Access Compliance Report Public Rights-of-Way (Curb Ramps)

Main Street: N/A Cross Street: IRVINE_AVE Location: S

ADA ID: RPRK211018123443 Ramp Type: Type 7 - Directional 2 Initial Pass/Fail: Fail Overall Compliance: No Severity Score: 15

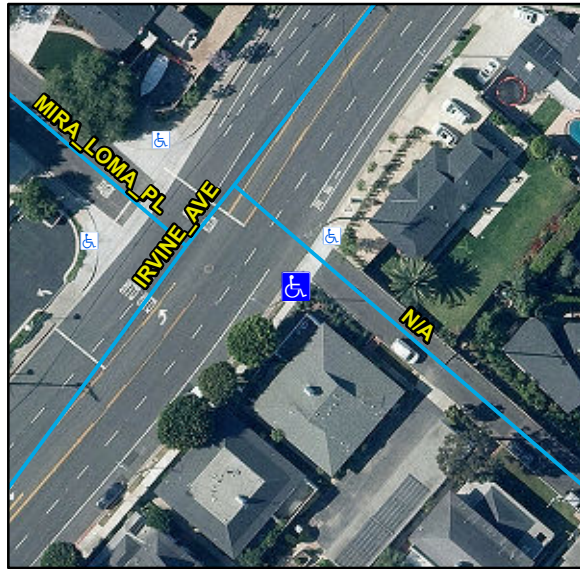
Compliance	Description	Data	Compliance	Description	Data
N/A	Ramp Length (in)	104	N/A	Flare Type LT	
Yes	Ramp Width (in)	90			N/A
No	Ramp Run Slope (%)	10.3	N/A	Flare Slope LT (%)	N/A
Yes	Ramp Cross Slope (%)	0.6	N/A	Flare Traversable LT	N/A
N/A	Grade Break	N/A	N/A	Flare Type RT	
N/A	Grade Break Slope (%)	N/A			N/A
N/A	Grade Break Cross Slope (%)	N/A	N/A	Flare Slope RT (%)	N/A
	Addl Para Ramp Left?	No	N/A	Flare Traversable RT	N/A
	Addl Para Ramp Right?	No	N/A	DWS Provided	N/A
N/A	Landing Present	N/A	N/A	DWS Contrast	N/A
N/A	Landing Length (in)	N/A	N/A	DWS Length (in)	N/A
N/A	Landing Width (in)	N/A	N/A	DWS Full Width	N/A
N/A	Landing Run Slope (%)	N/A		DWS Offset Type	N/A
N/A	Landing Cross Slope (%)	N/A	N/A	DWS Left Offset (in)	N/A
N/A	Landing Movement Obstructed?	N/A	N/A	DWS Right Offset (in)	N/A
	Landing Movement Type	N/A			
N/A	Landing Shared	N/A			
N/A	Marked Crosswalk 1	No	N/A	Clear Space	N/A
	Crossing 1 Direction	NE	N/A	Clear Space To Crosswalk (in)	N/A

Marked Crosswalk 1 Width (in)	N/A			
N/A	Ramp Inside Crosswalk 1	N/A			
	Crossing 1 Slope (%)	1.7			
	Crossing 1 Cross Slope (%)	1.9			
N/A	Gutter Ponding	N/A	N/A	Curb Slope	7
Yes	Gutter Lip Height (in)	0		Road Run Slope (%)	N/A
N/A	Gutter Run Slope (%)	N/A		Road Cross Slope (%)	N/A
N/A	Gutter Cross Slope (%)	N/A		Parallel Ramp Side	Left
Yes	Overall Surface Condition	Acceptable	Yes	Perp Joint Present	Yes
	Cross Gutter Present?	Yes		Spandrel Present?	Yes
	Replace Cross Gutter?	No		Replace Spandrel?	No

Remove & Replace Entire Ramp.
